Technical Memorandum

Subject: Workplan Addendum to Install Additional PRB Performance Monitoring Wells at the Former Tecumseh Products Site in Tecumseh, Michigan

Date: July 8, 2011

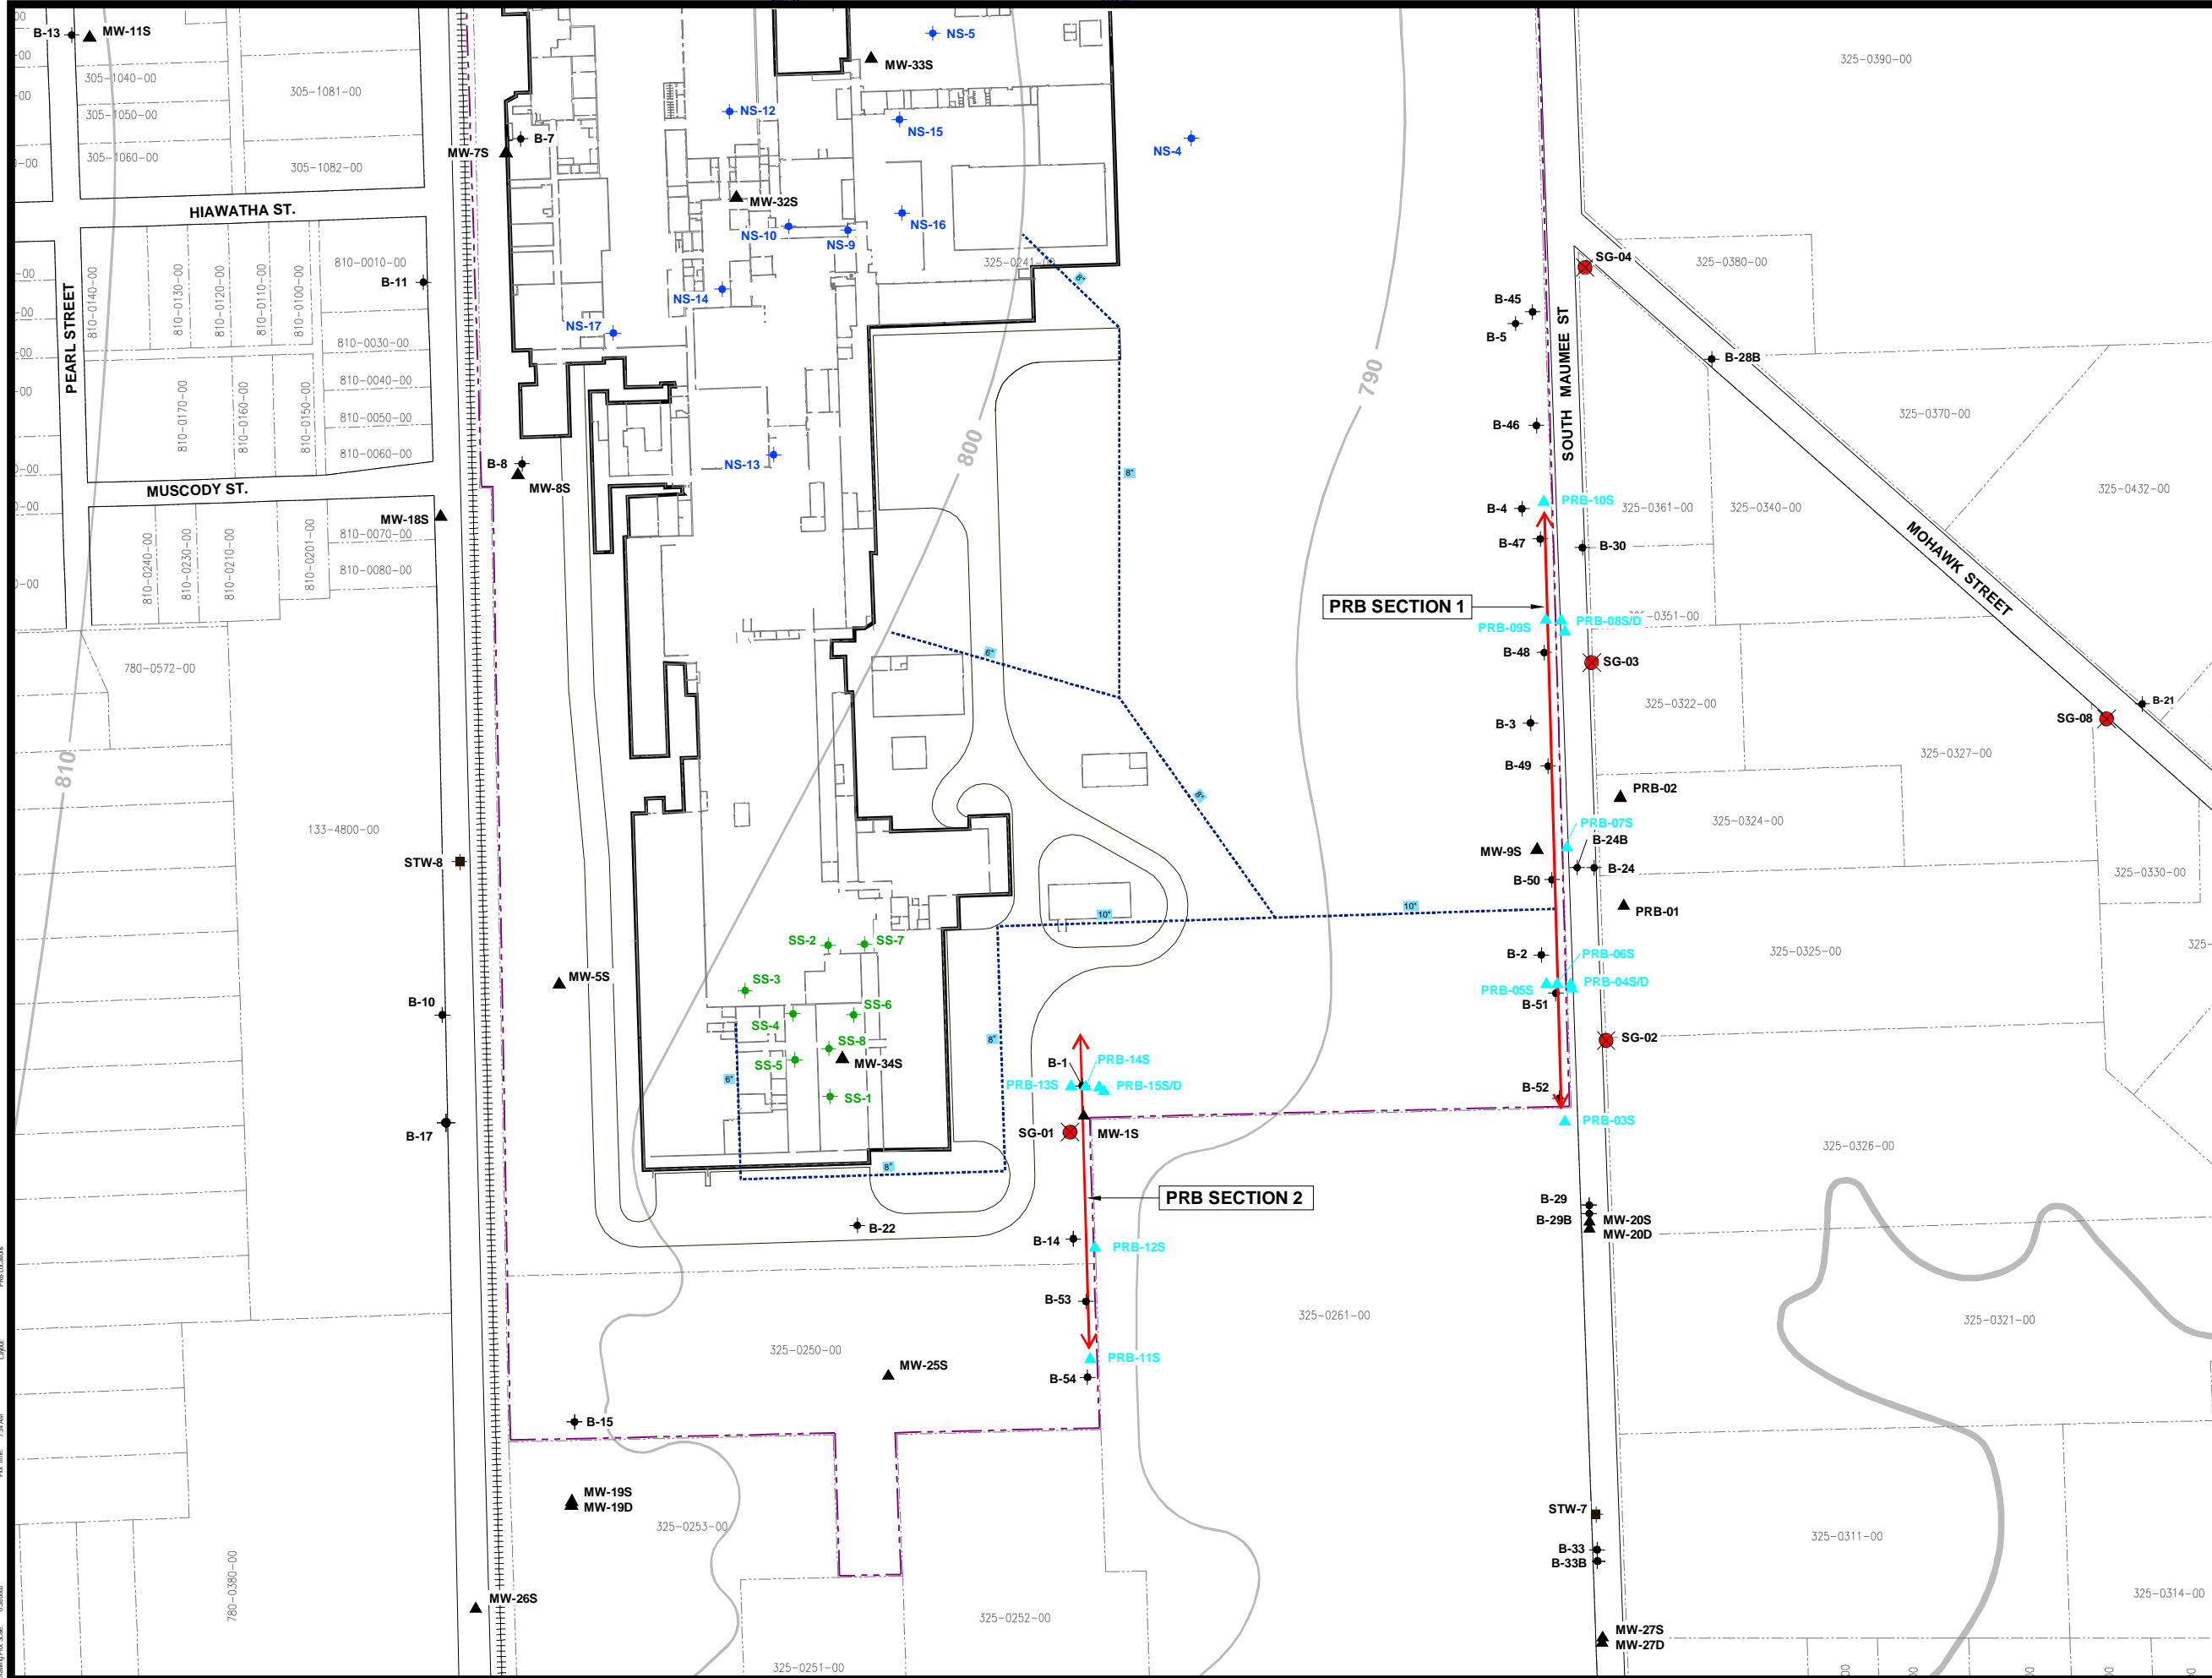
The approximate locations of the monitoring wells previously proposed are shown on Figure 4 of the Workplan. Four additional monitoring wells, as shown on Figure 1, were added to the proposed performance monitoring network to address USEPA comments. (Note previously proposed wells were renamed so that the final well designations are more logical relative to well locations.)

- One new deep monitoring well (PRB-8D) was added to the proposed network to assess the potential for vertical migration beneath Section 1a of the PRB.
- Three monitoring wells (PRB-06S, PRB-09S, and PRB-14S) located within the PRB were added to the proposed network to assess the performance of the PRB and to directly measure the hydraulic conductivity of the PRB.
